AMENDMENT UNDER 37 C.F.R. § 1.111
U.S. Appl. No.: 09/699,553
Attorney Docket No.: Q61563

AMENDMENTS TO THE DRAWINGS

FIG. 12

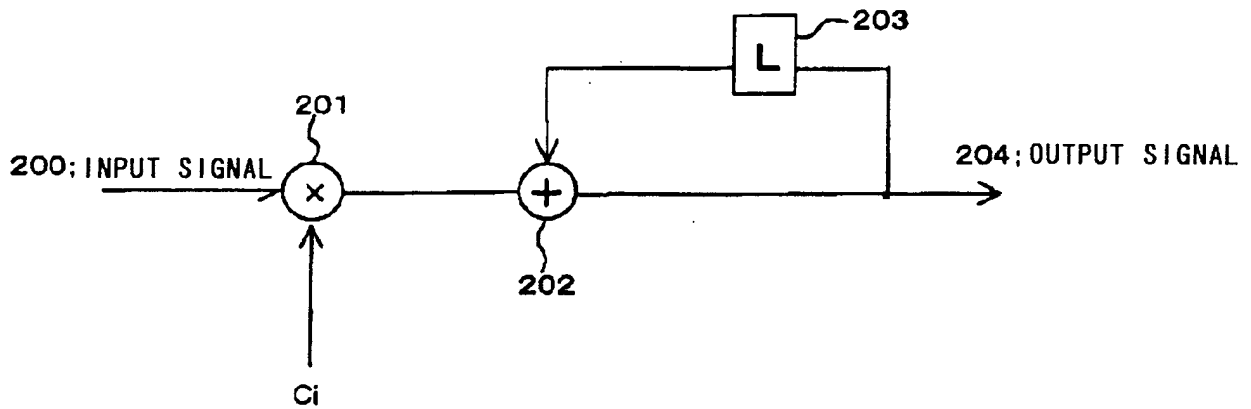
The drawings stand objected to because Figures 12 and 13 should be labeled as --Prior Art--. Applicant submits herewith new Figures 12 and 13 labeled as --Prior Art--. Accordingly, Applicant requests that the objection to the drawings be reconsidered and withdrawn. Please see the attached replacement sheets.

PRIOR ART
